RE: **Observation on Planning Reg Ref SD22B/ 0340**

**Register Ref:** SD22B/0340  
**Development:** Demolition of the rear single storey extension; alteration to the front facade which consists of 2 storey porch and staircase, 2 double bay windows on each side of the new porch, second storey extension to the side over existing garage with main roof extension over, single storey extension to the rear, attic conversion with new dormer type window to the rear, Velux type windows to the front and side of the main roof, widening vehicular access gate, some internal alterations and associated site works.  
**Location:** 6, Ballytore Road, Dublin 14  
**Applicant:** Roisin Moran and Shane Delaney  
**Application Type:** Permission  
**Date Rec'd:** 26-Jul-2022

NOTIONAL VIEW OF THE EASTERN EXTENSION & SIDE PASSAGE CANTILEVER PROPOSAL AT NO 6

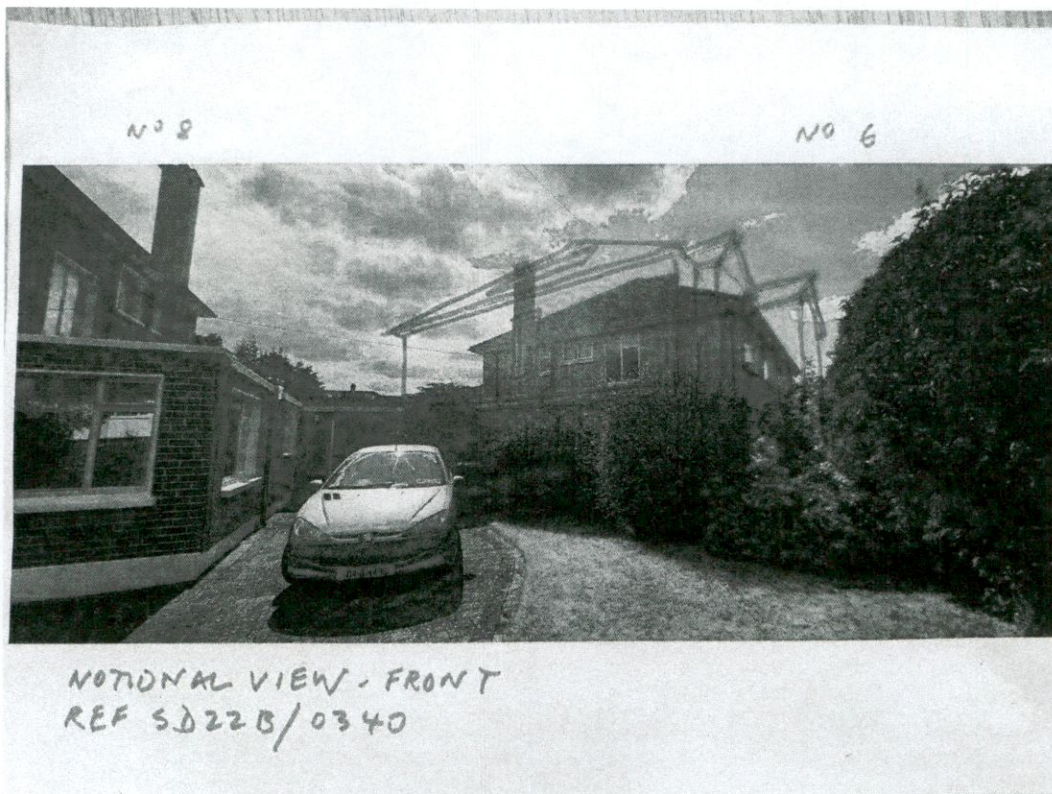
The proposed first floor extension over the former garage cantilevers over an open side passage (retained and modified from the existing arrangement) up to the centre line of an existing low boundary wall (100mm deep block; approx. 900mm high) with our property. Therefore the proposed cantilver oversails the existing party wall below it and as such is an encroachment on it; and would prevent the full potential for future development on the no 8 side. We have noted below how the eaves gutter roof construction, and gutter maintenance access required for it, suggests a further setback or re-design would be required to respect the party wall.

A new door and window are proposed on the ground floor of the former garage facing onto the open side passageway. This door and window would overlook the low wall onto our property without any mitigation on the privacy enjoyed currently. If this part of proposed ground floor plan was ever converted to, or is intended to be, an independently accessed residential unit, there would be an added security threat to my property and a loss of privacy unless the side passage was enclosed up to the front of façade of no 6. This issue should be clarified and fully addressed.

A first floor window is proposed at first floor on the party/ line, along the east boundary of the extension on this side, looking straight into no 8. This proposal is an infringement of my privacy and a curtailment of the potential for future development on my side of the boundary. A proposal for a window on a shared boundary, on ground or first floor, without the agreement of the neighbour, should not be permitted.

The east side of the two storey extension over the garage proposes an eaves gutter along its entire length which will extend past the party wall centre line with no 8 and thereby preclude future development on the no 8 side. An eaves gutter so close to a boundary will also require access from no 8 to maintain it. A sufficient set back that respects the party line, the full width of a party wall at this height, as well as a redesign to facilitate full maintenance access from no 6 side only, is necessary.
